United States Patent and Trademark Office

APPLICATION NO.	FILING DATE	FIRST NAMED INVENTOR	ATTORNEY DOCKET NO.	CONFIRMATION NO.
10/612,649	07/02/2003	Joo Sun Yoon	21C-0058	5474
CANTOR CO	7590 01/17/2007	EXAMINER		
55 Griffin Road South			DUONG, THOI V	
Bloomfield, C	F 06002		ART UNIT	PAPER NUMBER
		•	2871	
			· 	
SHORTENED STATUTORY PERIOD OF RESPONSE		MAIL DATE	DELIVERY MODE	
3 MONTHS		01/17/2007	PAPER

DETAILED ACTION

FIG. 5a

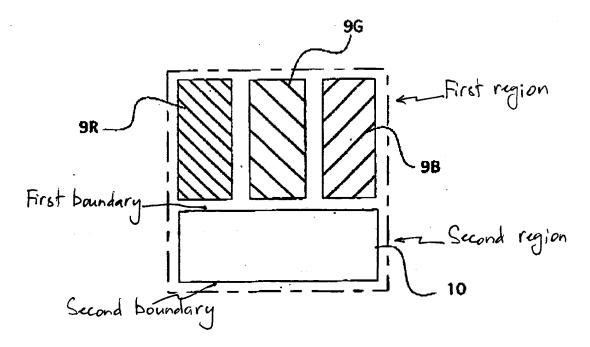
As shown in Figs. 4 and 5a, Kubota discloses a reflective-transmissive type liquid crystal display device comprising a pixel electrode 3 including an electrode for a reflective display 3a (reflective electrode) disposed on a first region (reflective display region) facing a color filter 9 of red (R), green (G) and blue (B) disposed on a counter substrate 5; and an electrode for a transmissive display 3b (transmissive electrode) disposed in a second region (transmissive display region) facing a non-color layer 10 disposed on the counter substrate 10 without being covered by the reflective electrode (col. 8, lines 14-21 and col. 12, lines 25-32); and an alignment layer 7(7a, 7b) coated on an upper surface of the pixel electrode 3.

Accordingly, as shown in Fig. 5a (annotated), the second region facing the non-color layer 10 includes a first boundary and a second boundary, where the first boundary is a boundary between the first and second regions and the second boundary is an exposed edge of the second region.

Thus, it would have been obvious to one having ordinary skill in the art at the time the invention was made to modify Applicant's Prior Art with the teaching of Kubota by forming a pixel electrode having a reflective electrode formed in the first region and a

transparent electrode formed in the second region, the second region including a first boundary and a second boundary where the first boundary is a boundary between the first and second regions and the second boundary is an exposed edge of the second region in order to obtain a device capable of precisely controlling the alignment of liquid crystal molecules, and of providing a display with high brightness and high color purity both in a transmissive display mode and in a reflective display mode (col. 3, lines 13-18).

Since Applicant's Prior Art in view of Kubota has the same structure with the instant invention, claimed properties or functions recited in claims 1 and 14 are presumed to be inherent (see MPEP 2112.01); therefore, it is obvious that the orientation groove rubbed in a first direction toward the second region including the first boundary and the second boundary also prevents impurity from being stacked at the first boundary of the transparent electrode.
